**GROWTH MANAGEMENT DEPARTMENT STAFF REPORT**  
**NORTH COASTAL OVERLAY DISTRICT**  
**May 10<sup>th</sup>, 2023 Public Meeting**  
**NCDRB 2023-02 Mussallem Park – Phase III**

**To:** North Coastal Design Review Board  
**Staff:** Sloane Stephens, Planner  
**Date:** May 3, 2023

**Summary of Request:** This item is a request for design approval for the construction of a scenic overlook, trail, and restrooms. Staff notes that this is an allowed use by right based on the zoning and future land use of the subject property.

**C1 SOUTH ELEVATION**  
SCALE: 1/4" = 1'-0"

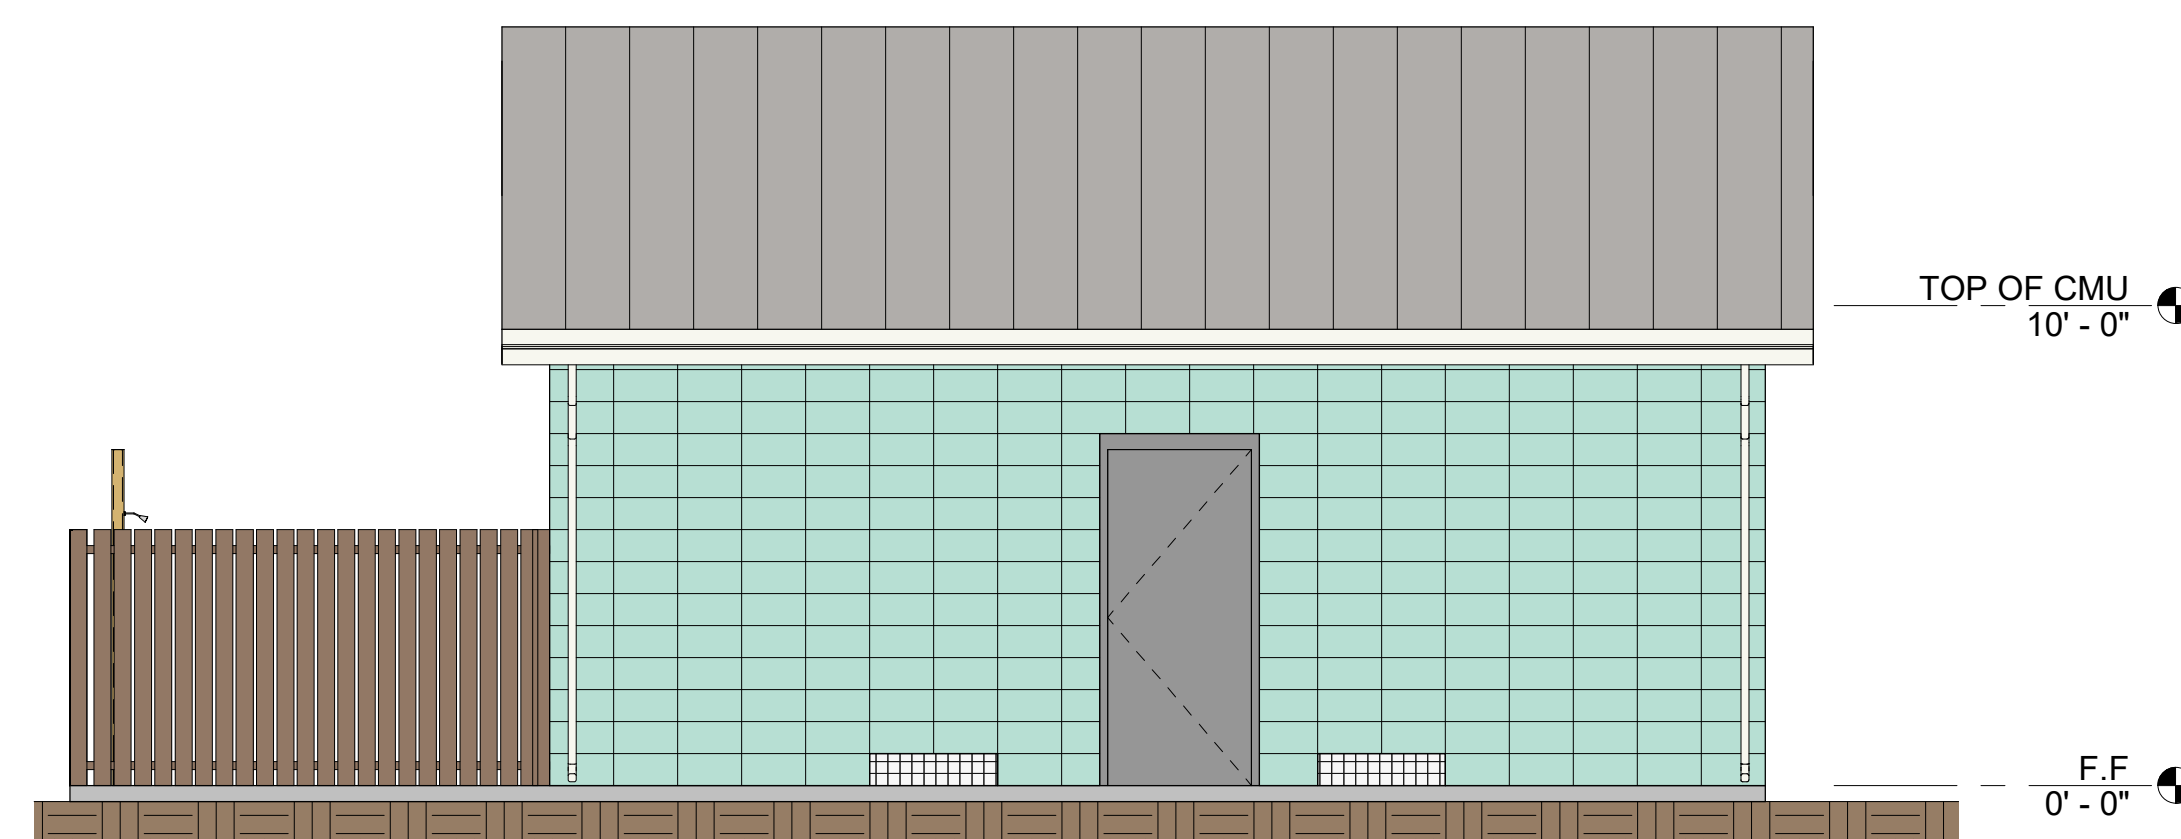
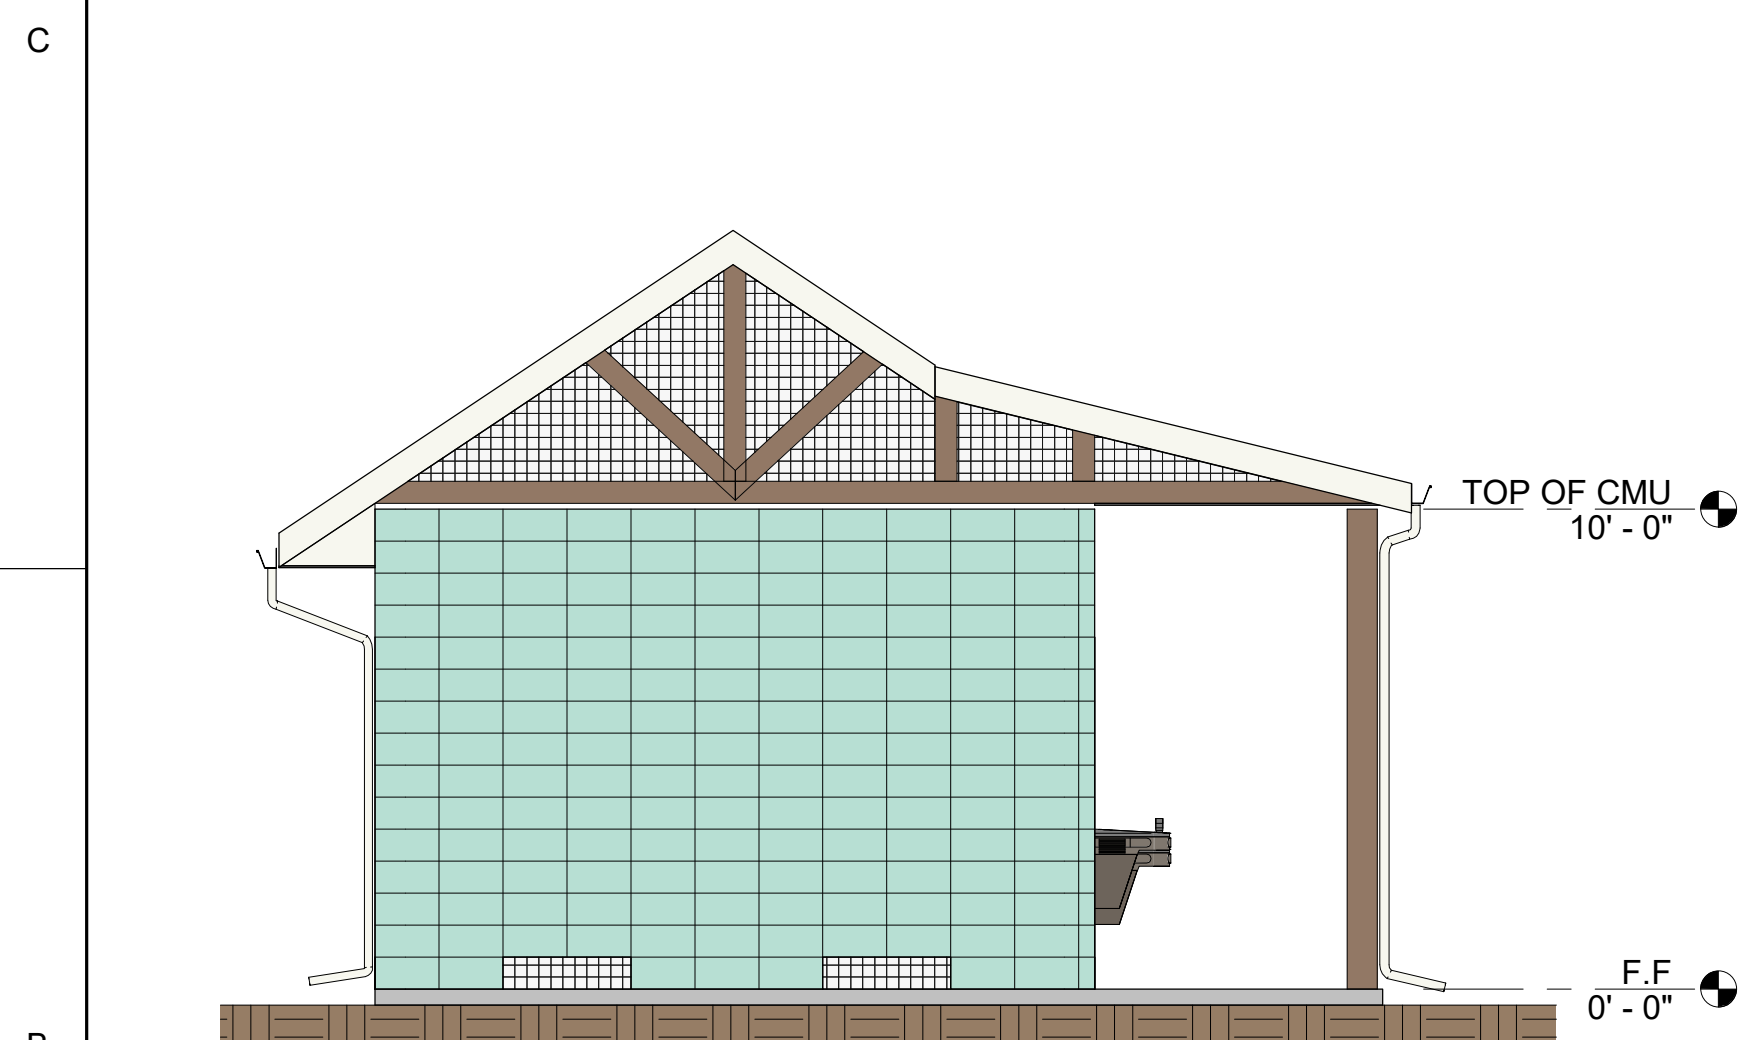
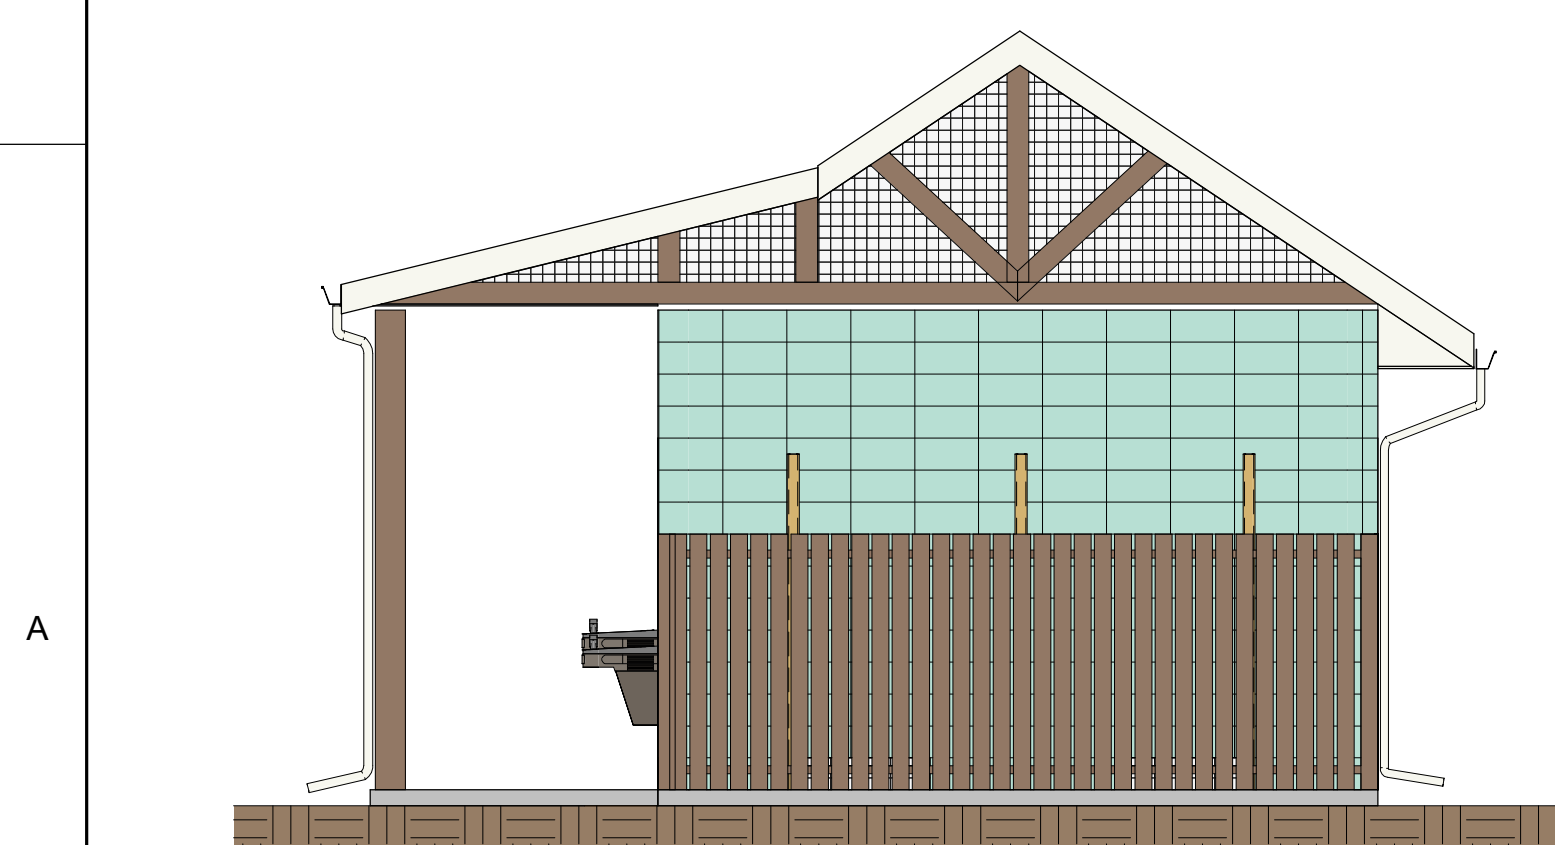
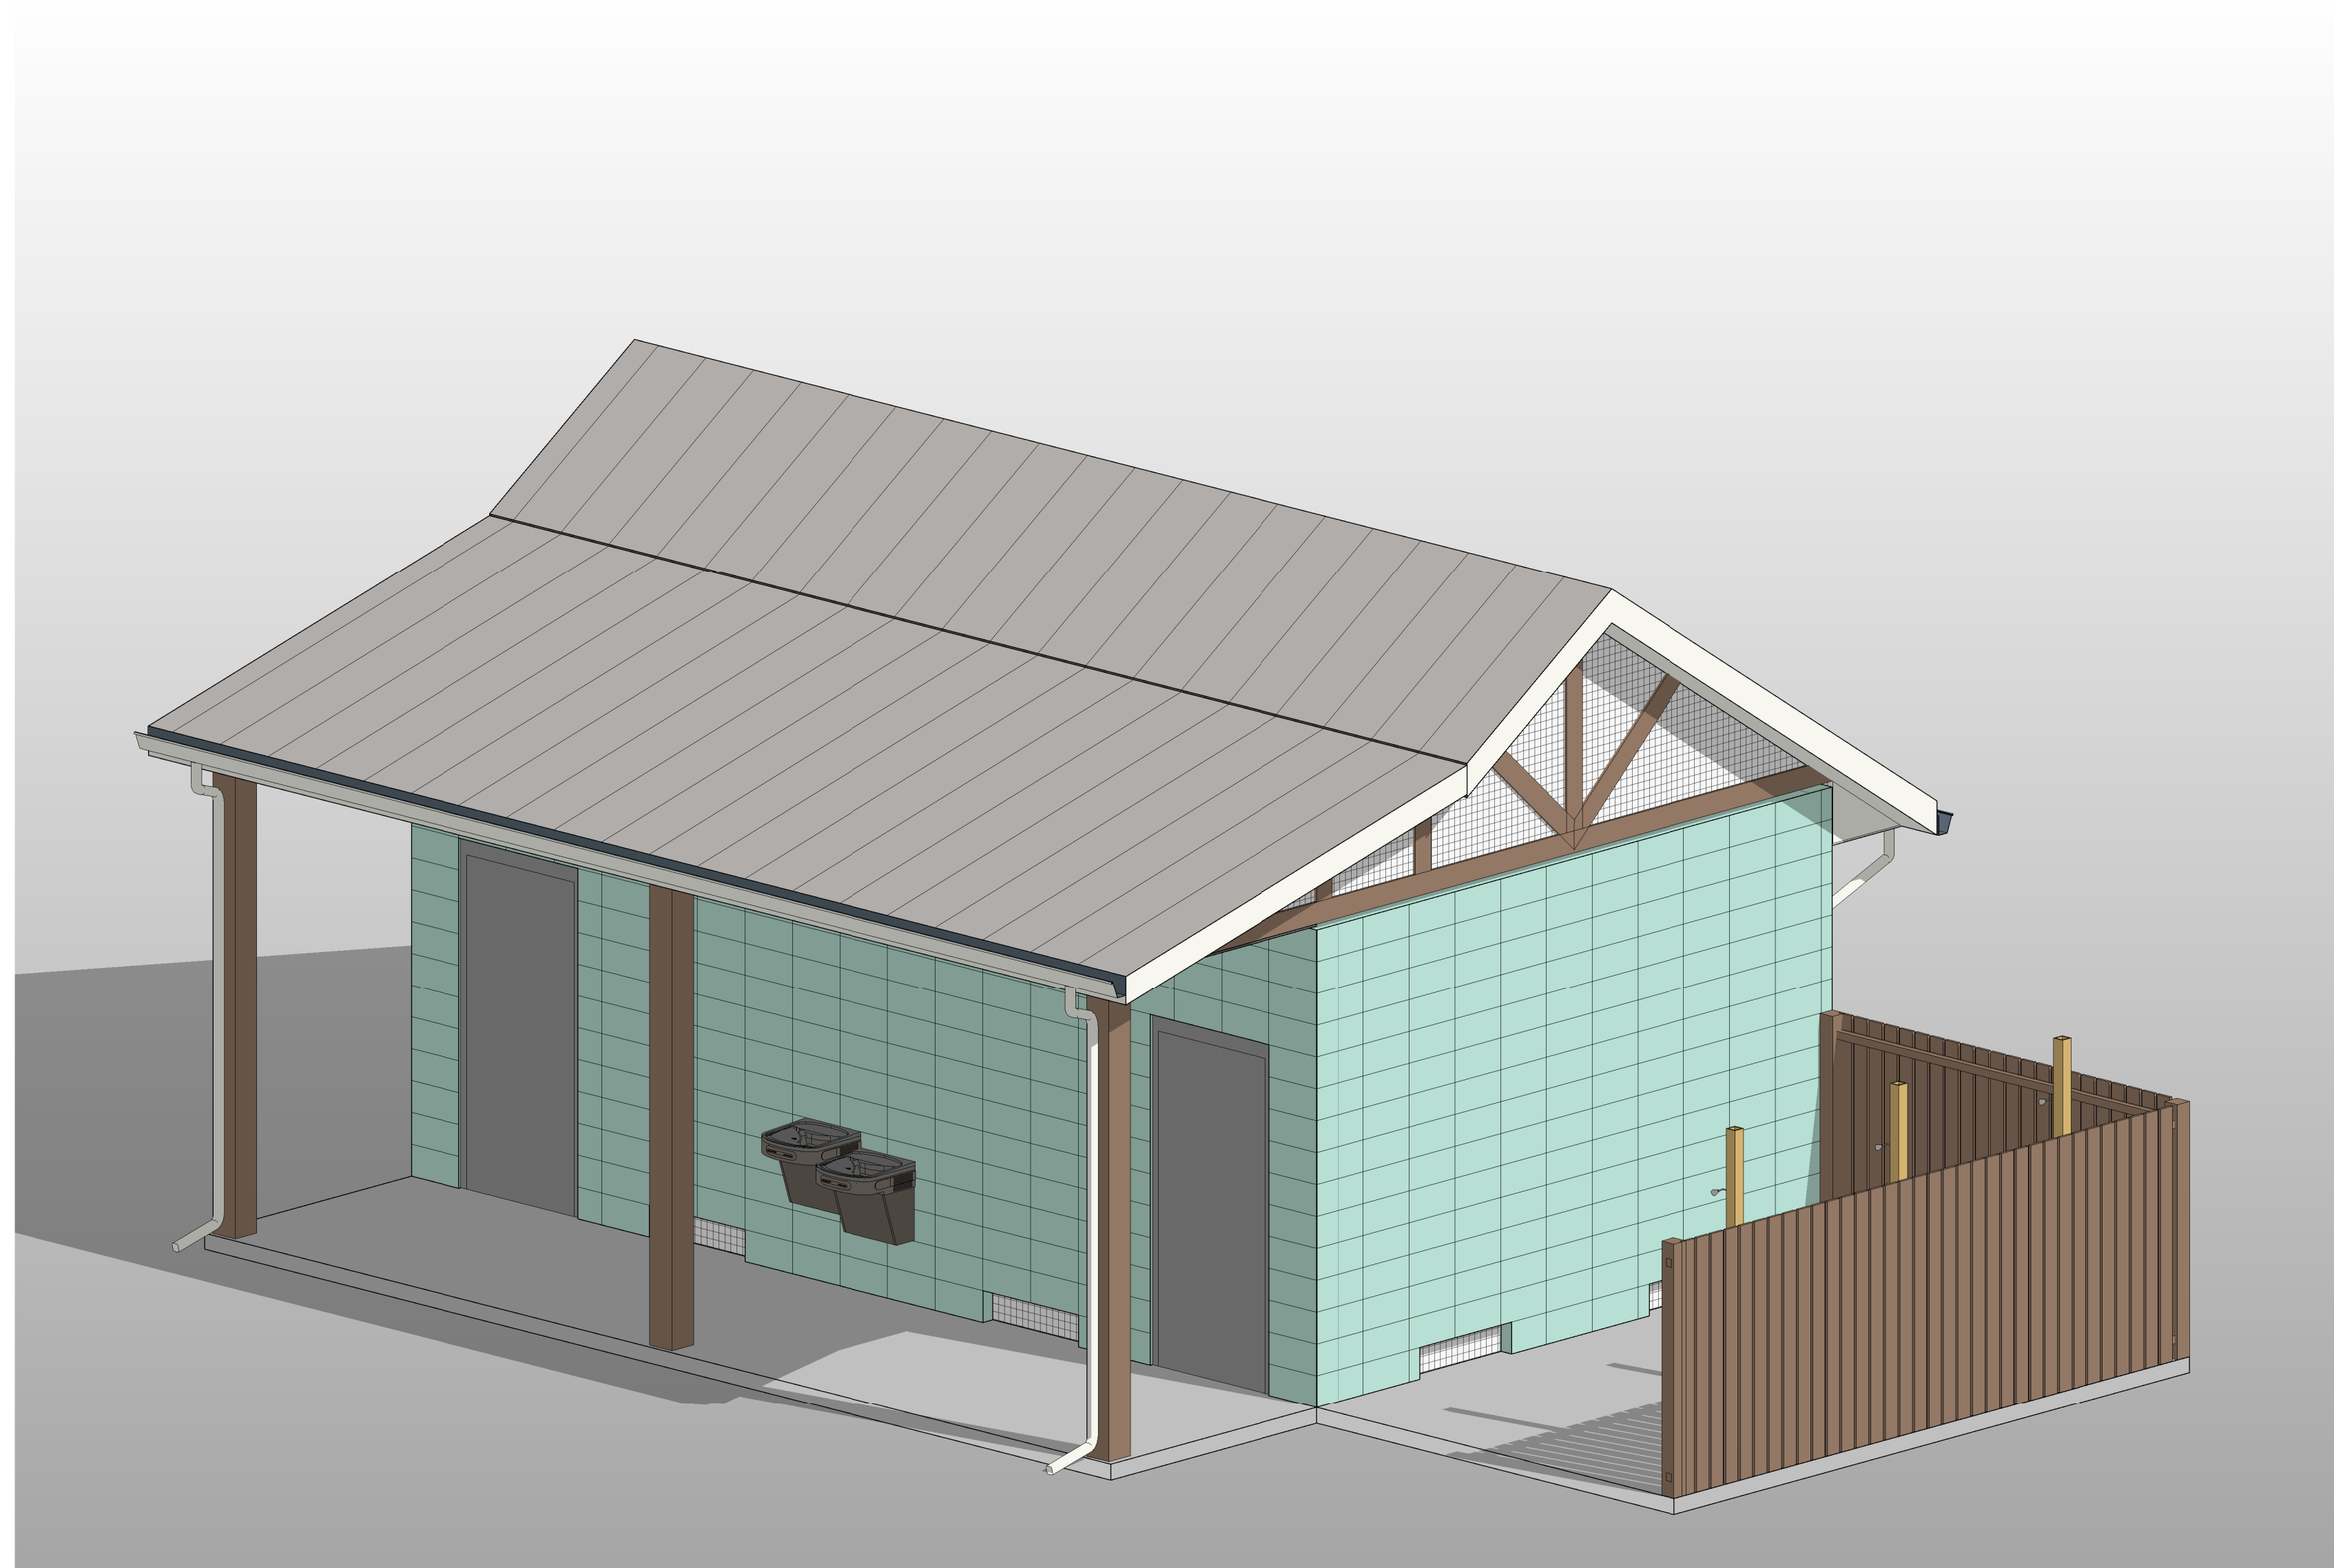
1. Horizontal wood siding, wood shingles and board and batten with gable or hipped roofs of metal or composition shingles. *Roofing is proposed to be metal.*

2. Wide wrap-around porches and large windows with shutters. *There are no porches on proposed structures.*
3. Wide overhanging eaves and breezeways were typically incorporated to provide shade and maximum ventilation. *The restroom structure provides a shaded overhang area.*

4. Exterior colors of paints and stains for new Building or Structure Construction or Development may be nature-blending or pastel colors, with no more than three colors per building, excluding roof color, unless approved by the Design Review Board. All exterior color hues should be subdued, consistent. In general, such hues of greens, yellows, corals, browns, blues, grays, tans and beiges shall be considered appropriate. Building materials and exterior finish surfaces include stucco, cement composite, wood siding or wood shingle, brick, exterior insulation-and-finish systems (EIFS), or other materials with similar texture and appearance shall be considered appropriate. Public art such as murals will not be applicable to the color standards in this paragraph. The design of the mural will not exceed a maximum of fifteen percent (15%) of the façade in which it is located unless additional area is approved by the DRB. *Proposed colors and materials appear consistent with these standards.*

5. Architectural grade shingles, metal standing seam, 5 V Crimp metal roofing, tile or other non-reflective roof materials with similar nature-blending texture and appearance shall be considered appropriate. Roof angles should be a minimum of twenty (20) degrees and may incorporate dormer windows. *Metal standing seam roof is proposed.*
